#### THE ALTERED PLAN OF BRIDGEWATER HOUSE, LONDON.

We have been asked to give some information concerning the alterations which have been made in the internal arrangement of Bridgewater House, Cleveland-row, and cannot better comply with the request than by annexing a plan of the house as it is now proposed to be completed, which may be compared with the original plan given in our last volume (VI.), page 474.

PRESENT PLAN OF BRIDGEWATER HOUSE.

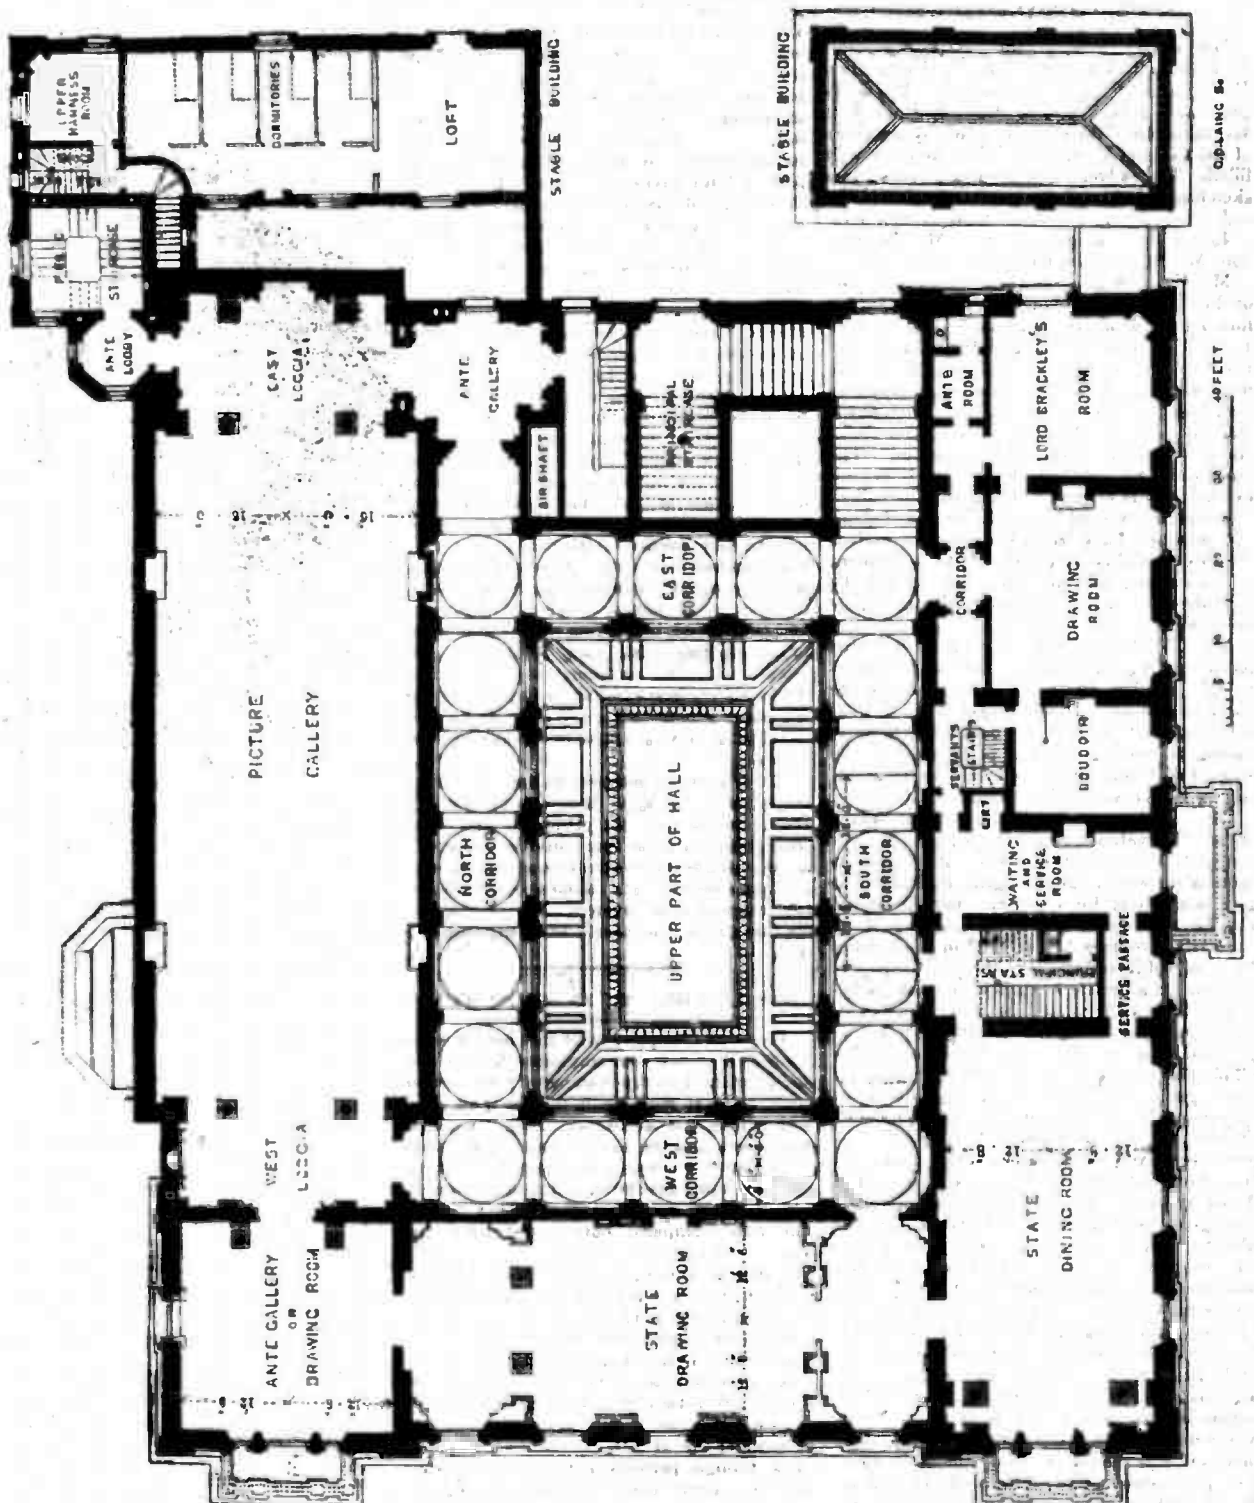
"With respect to the alteration in Bridgewater House, it might, in my opinion, have been better contrived. According to the first plan, there was no inner central hall on the ground-floor; now, on the contrary, there is too much,—one so disproportionately spacious and lofty, that, with the exception of the picture-gallery, all the rooms must look small by comparison with it,—that is, much smaller than they need do, or would have done, according to the first arrangement. Another

objection is, that, on its being first entered below, just as much will be seen as after ascending the staircase. Perhaps it would be better were the corridors to be partly enclosed, so as to leave only eight of the sixteen arcades open to the upper part of the hall, viz. three on each side and one at each end, which might be done not by stopping up those at the angles, but by merely glazing them with ornamental diapered or mosaic glass, in patterns of various colours; in which case the corresponding arcades below, if the corridors on the ground-floor be also quite open to the hall, ought to be closed up solid. That would confine the space sufficiently, and instead of the whole being disclosed at the first glance, parts would come into view successively,—would, after first appearing, disappear, and then appear again. It is not every architect that has a *forte* for plan—for so 'laying out' a mansion as to secure various effects by means of piquant contrasts, transitions, and combinations.
